Form 3160-5
(June 2019)UNITED STATES
DEPARTMENT OF THE INTERIOR
BUREAU OF LAND MANAGEMENTFORM APPROVED
OMB No. 1004-0137
Expires: October 31, 2021**SUNDRY NOTICES AND REPORTS ON WELLS**
Do not use this form for proposals to drill or to re-enter an abandoned well. Use Form 3160-3 (APD) for such proposals.

8. Well Name and No. ROSS DRAW 17 FED COM/704H

EOG respectfully requests an amendment to our approved APD for this well to reflect the following changes:

Revised Wellbore

WELL LOCATION AND ACREAGE DEDICATION PLAT

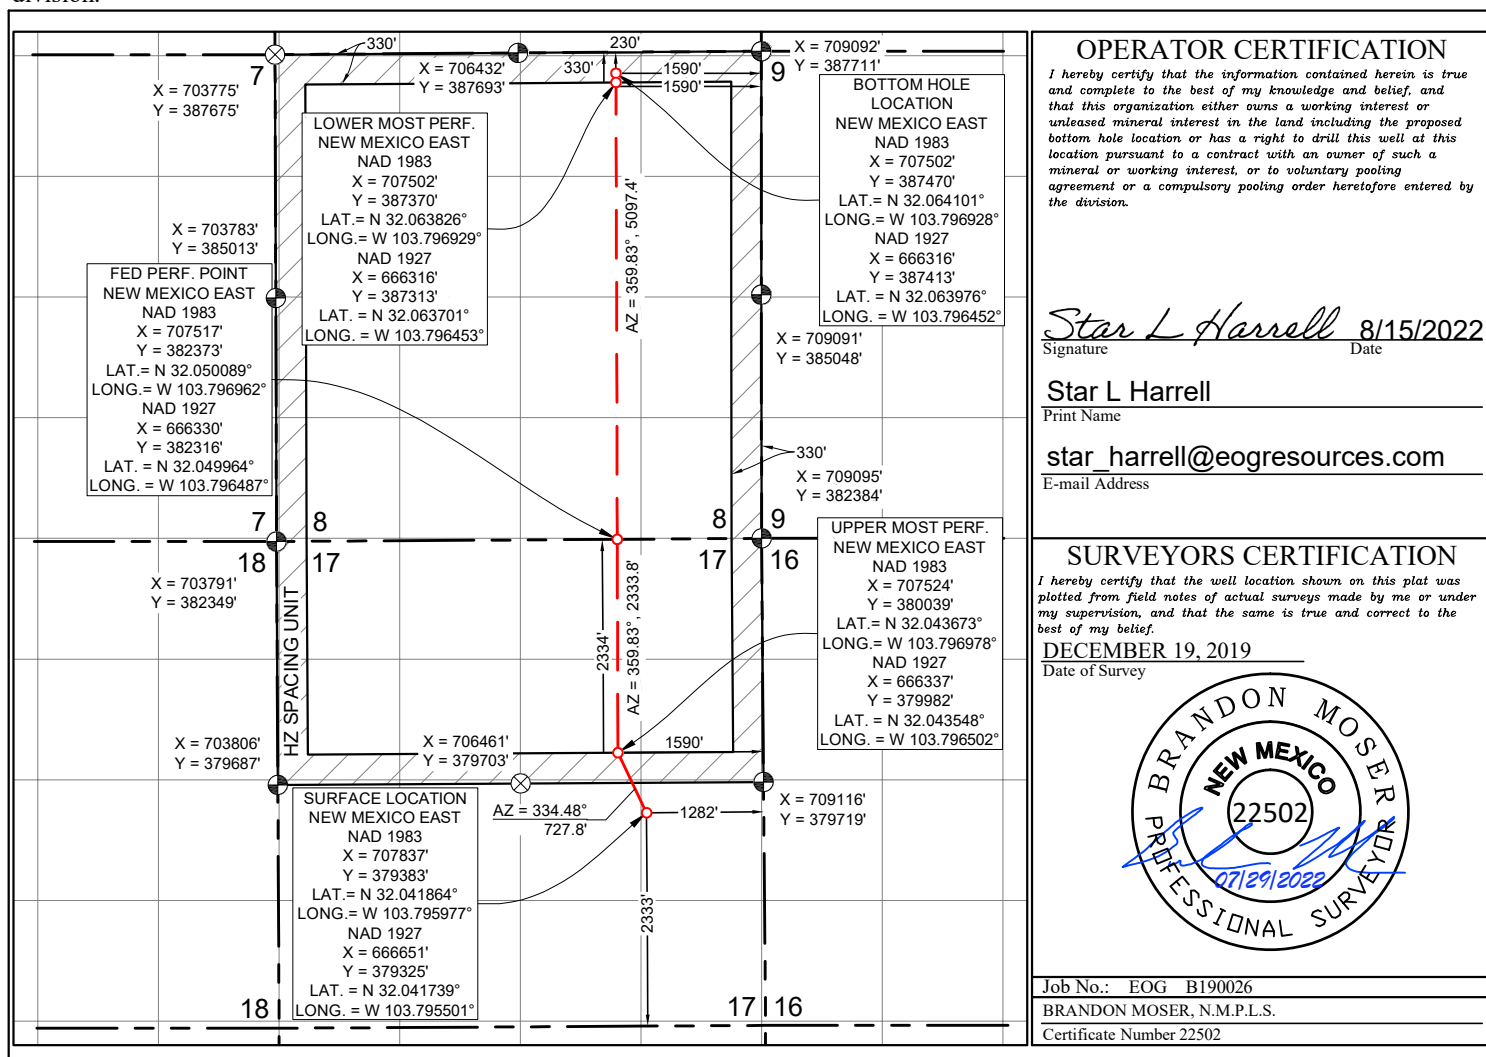
Change SHL from T-26-S, R-31-E, Sec 17, 2464' FNL, 1627' FEL, Eddy Co., NM, to T-26-S, R-31-E, Sec 17, 2333' FSL, 1282' FEL, Eddy Co., N.M.

Change BHL from T-26-S, R-31-E, Sec 8, 230' FNL, 1310' FEL, Eddy Co., NM, to T-26-S, R-31-E, Sec 8, 230' FNL, 1590' FEL, Eddy Co., N.M.

Update HSU to 960 acres.

UL or lot no.	Section	Township	Range	Lot Idn	Feet from the	North/South line	Feet from the	East/West line	County
I	17	26 S	31 E		2333	SOUTH	1282	EAST	EDDY

UL or lot no.	Section	Township	Range	Lot Idn	Feet from the	North/South line	Feet from the	East/West line	County
B	8	26 S	31 E		230	NORTH	1590	EAST	EDDY
Dedicated Acres 960.00	Joint or Infill	Consolidated Code	Order No.

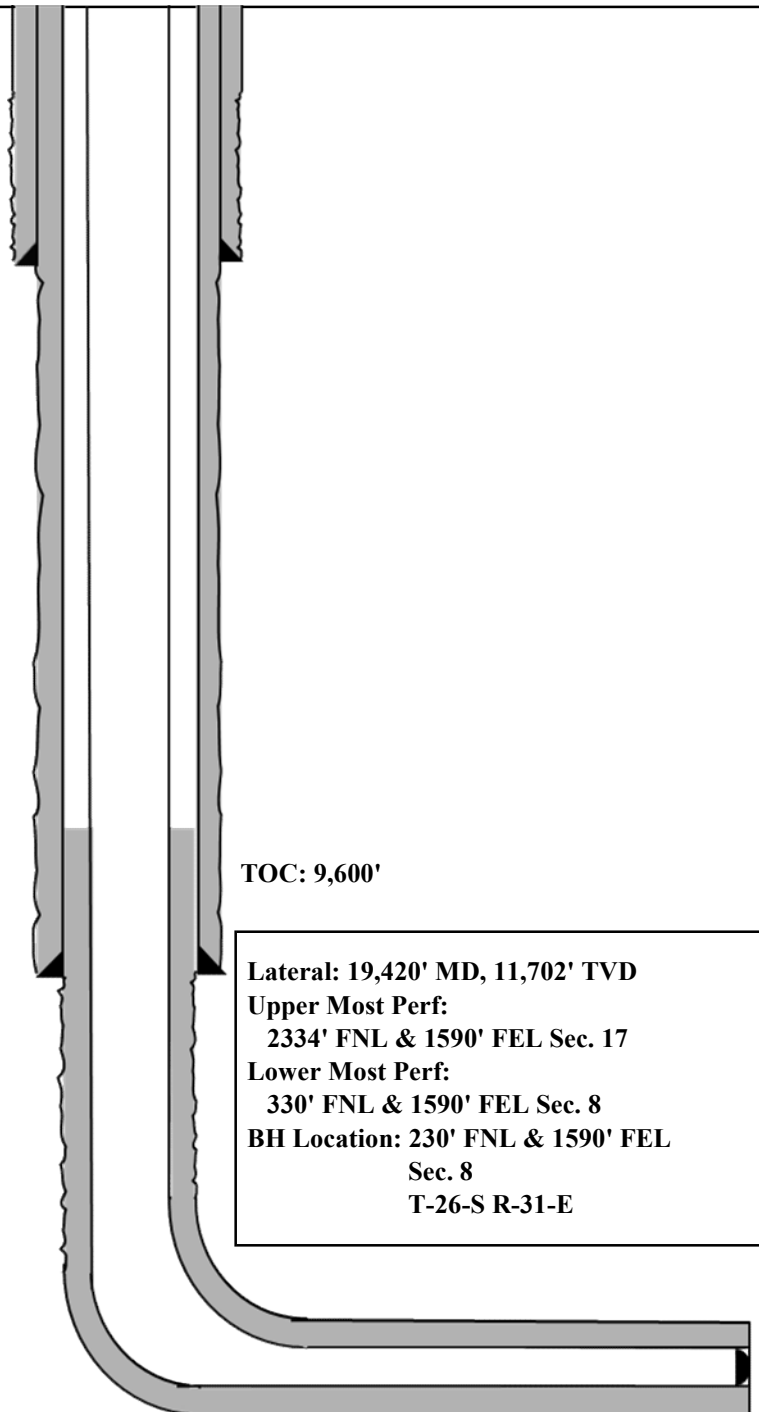
Update casing and cement program to current design.

Bit Size: 12-1/4"
9-5/8", 36#, J-55, LTC,
@ 0' - 1,310'

Bit Size: 8-3/4"
7-5/8", 29.7#, HCP-110, FXL,
@ 0' - 10,100'

Bit Size: 6-3/4"
5-1/2", 20#, P110-EC, DWC/C IS MS,
@ 0' - 9,600'

5-1/2", 20#, P110-EC, Vam Sprint SF,
@ 9,600' - 10,100'

5-1/2", 20#, P110-EC, DWC/C IS MS,
@ 10,100' - 19,420'
